BASIS OF DESIGN EXCEPTION

- Request for Approval of Design Exceptions to AASHTO Guidelines
- Request for Approval of Design Exceptions from Standard SCDOT Procedures

Attachment A – Design Exception

SUBJECT: Carolina Crossroads Project
Project ID P027662

5-lane 12'-4.75' taper shoulders

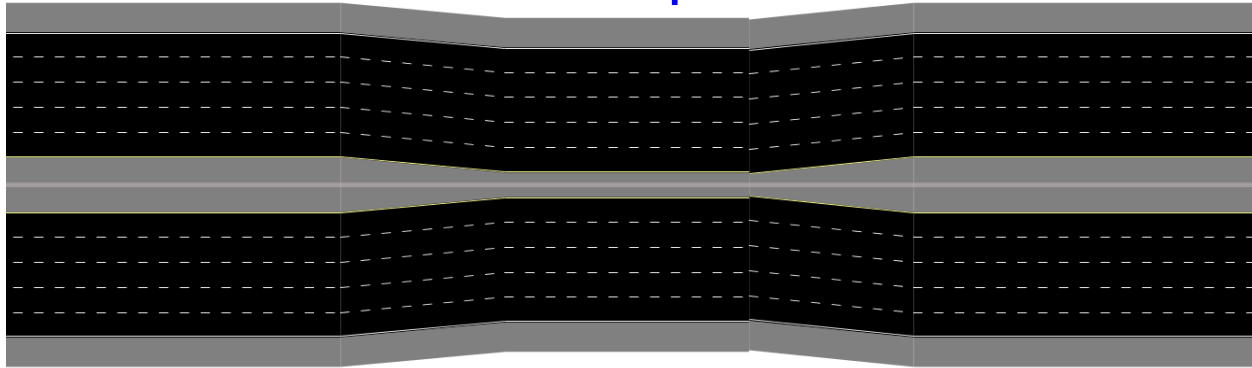
In order to complete the requested review, a sample interstate corridor similar to the proposed cross sections provided with the request was modeled. This sample model consisted of a 0.25 mile section of 4-lane interstate and 5-lane interstate. Projected AADT's were input as 90,000 and 100,000 VPD in the years 2020 and 2040 for the 4-lane section; along with 120,000 and 130,000 VPD for the 5-lane section. In order to get a baseline prediction of crashes for comparison, a maximum straight shoulder width of 12' was used to estimate a total number of crashes over a ten year period for the given conditions of each theoretical corridor. Subsequent crash totals were modeled by reducing the inside shoulder width for a section of the corridor to estimate the effects of a narrower inside shoulder at a point on the interstate due to interchange bridge piers and or barriers. The reduced shoulder widths were modeled for a length of approximately 225', of which 95' was the length of the fully reduced width, along with variable widths before and after this reduced width due to the leading and trailing tapers. These taper lengths started from a full 12' width shoulder, and tapered for a length of approximately 65'. The reduced shoulder widths that were sampled are as follows; 4.75', 6', 7', 8', 9', 9.75', 10', & 11' and are shown in the table below. Also shown is a sample plan view produced from the IHSDM software.

5-Lane Interstate Corridor									
Reduced Shoulder Width at Bridge	4.75' (Existing)	6.0'	7.0'	8.0'	9.0'	9.75' (Proposed)	10.0' (Required)	11'	12' No reduction in shoulder width
Total Crashes (10 years)	70.9	70.7	70.6	70.5	70.4	70.3	70.2	70.1	69.9

4-Lane Interstate Corridor									
Reduced Shoulder Width at Bridge	4.75' (Existing)	6.0'	7.0'	8.0'	9.0'	9.75' (Proposed)	10.0' (Required)	11'	12' (No change)
Total Crashes (10 years)	55.8	55.6	55.5	55.4	55.3	55.2	55.2	55.1	55.0

For the conditions outlined above and used in the IHSDM, results predict that there would be approximately 1 additional crash every 10 years in the worst case scenario of reducing the inside shoulder width from 12' to 4.75' for approximately 225'. There was practically no additional crash experience between the proposed 9.75' and minimum required width of 10.0'

Based upon these results with the provided input values, there does not appear to be any adverse safety effects at these point locations due to a reduction in shoulder widths.

INTERSTATE MAINLINE WITH MEDIAN BARRIER WALL
 INTERSTATE I-20 FC= URBAN INTERSTATE DS= 60 MPH
 STA. XXX + XX.XX - XXX + XX.XX

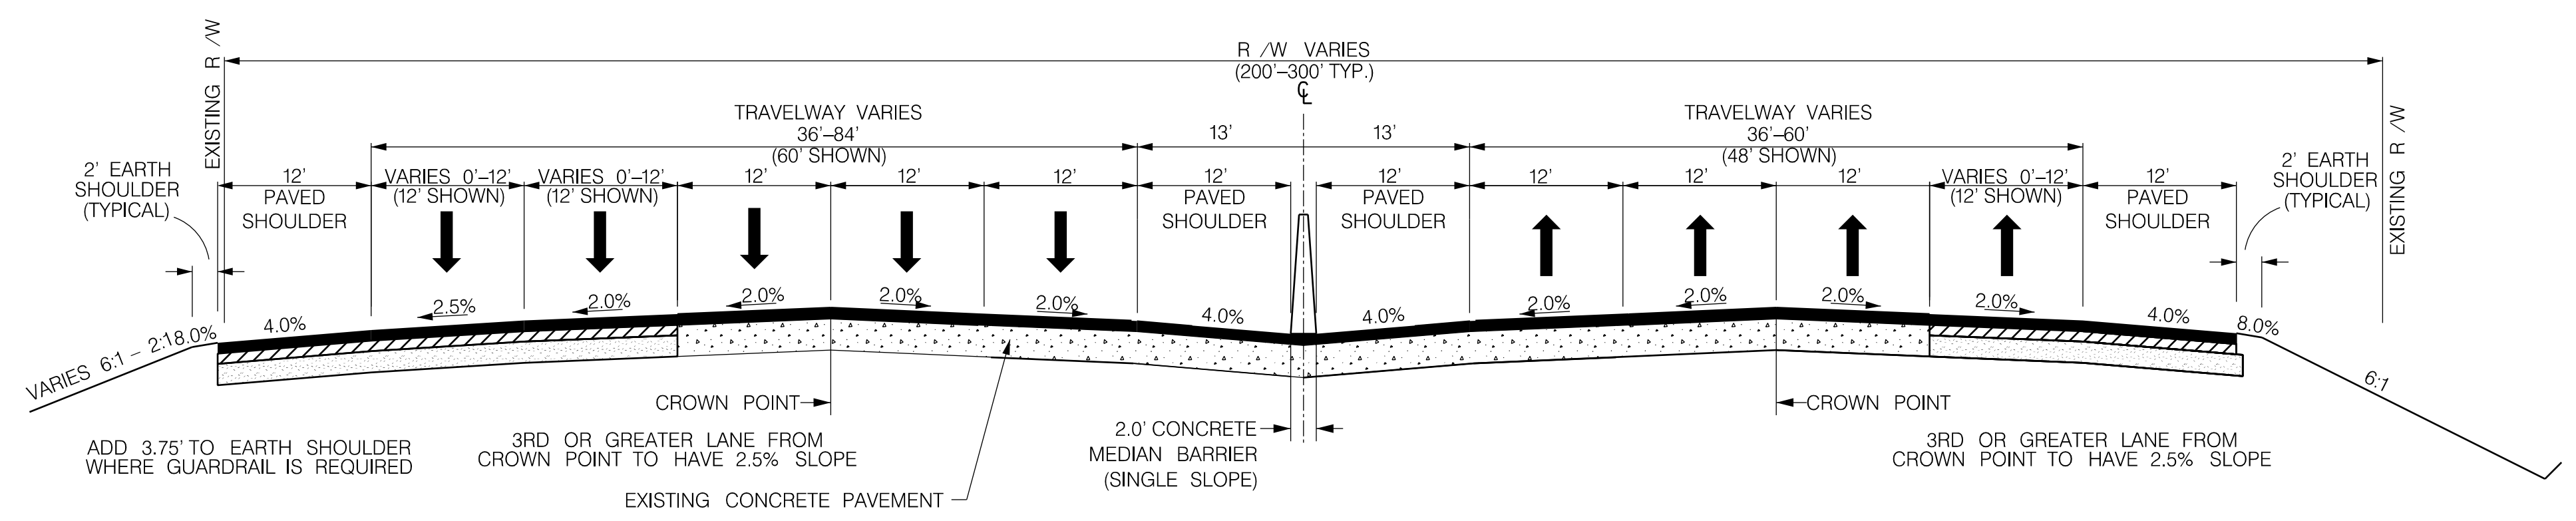
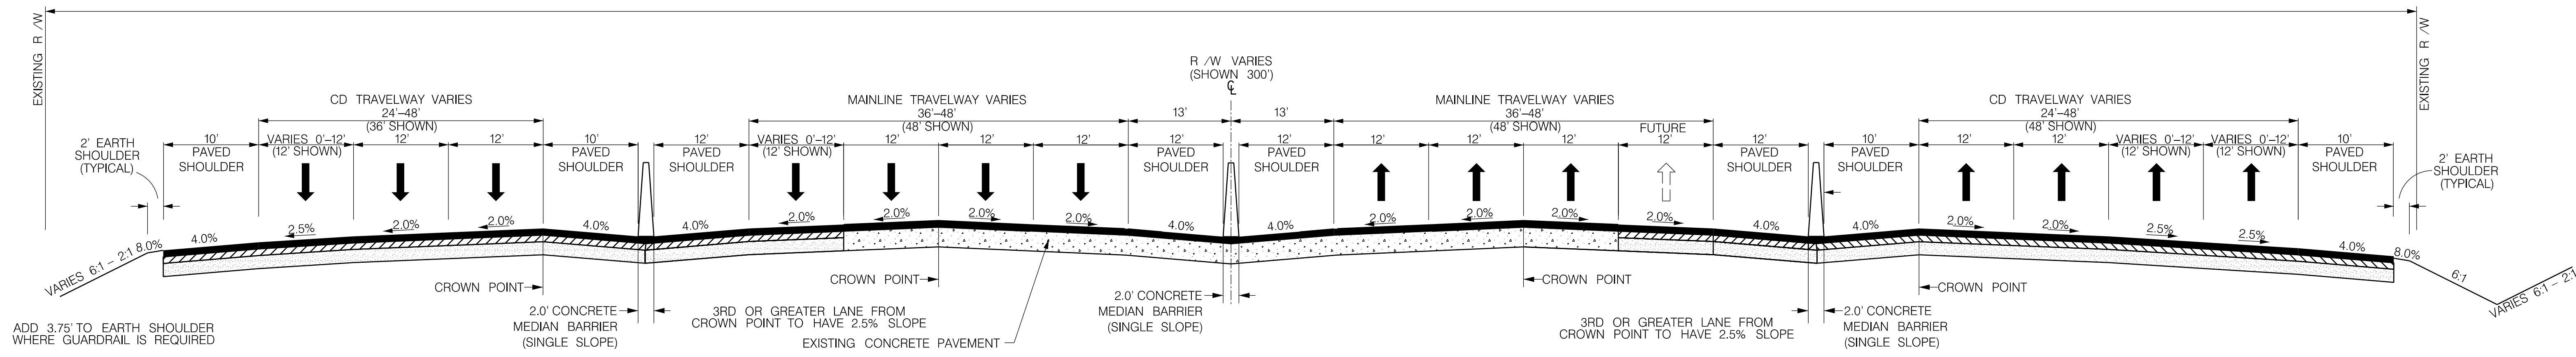
Bridges along I-20 within the project limits of Carolina Crossroads would be reconstructed as part of the Carolina Crossroads project. The existing inside shoulder width along I-20 is approximately 4.75'. The proposed inside shoulder width is 12'. The minimum inside shoulder width for interstates with 3 or more lanes is 10'. For overpassing bridges constructed with assumed 4' diameter columns the inside shoulder width would be reduced from 12' to 9.25'.

The design exception is requested to allow spot locations where the inside shoulder would be less than 10' (approximately 9.25') but greater than the existing 4.75'. Stopping sight distance would still be provided per the contract documents for the design-build project.
